UNITED STATES PATENT AND TRADEMARK OFFICE

APPLICATION NO.	FILING DATE	FIRST NAMED INVENTOR	ATTORNEY DOCKET NO.	CONFIRMATION NO.
10/511,071	10/12/2004	Steven Victor Jones	BR8812	7044

Office Action Summary

DETAILED ACTION

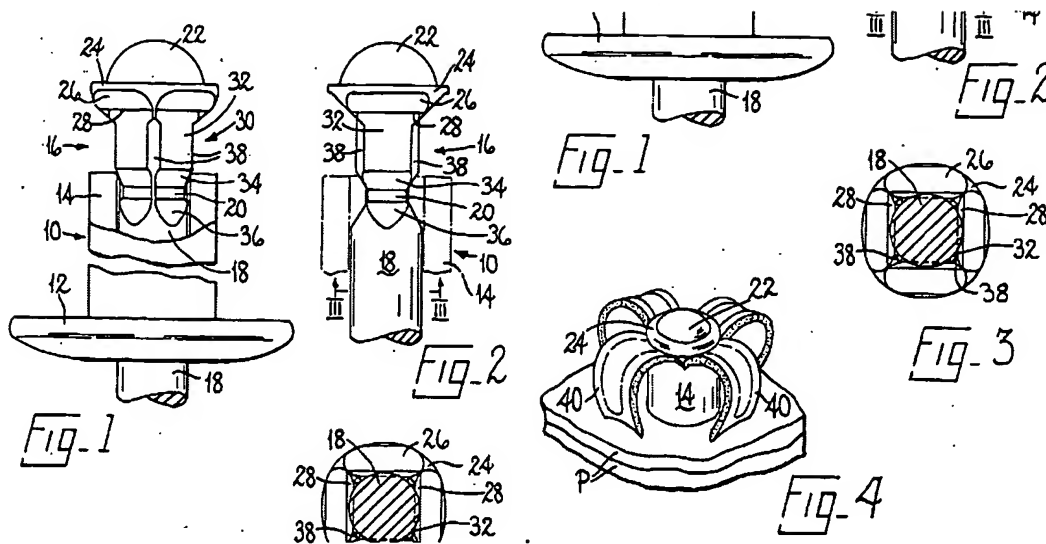
8. Claims 1-2 are rejected under 35 U.S.C. 102(b) as being anticipated by Potzas USP 4620825.

Re claims 1-2: Potzas in Figs 1-4 (above) teaches Potzas teaches a peel type blind rivet (abstract) settable in soft material, having an elongate body 10 with a shank and preformed head 12 at one end, and a plurality of slots 12 terminating at the end remote from the head. There is a mandrel (16, column 2 lines 49-50) having a stem (18) which extends through coaxial with said body and having an enlarged head (22) with a maximum external diameter greater than the internal body diameter (Figs above). The mandrel head forms a shoulder between the mandrel stem and an outer surface of the head, -- the deforming means (head) presents a substantially flat surface perpendicular to an axis of said mandrel, in that the underside of head 22 terminates in plane forming flat shoulders 28 normal to axis of stem, which as shown in Figs 1- 4 and discussed in column 2 lines 62-68 is described as "flat shoulders 28 normal to the axis of the mandrel".
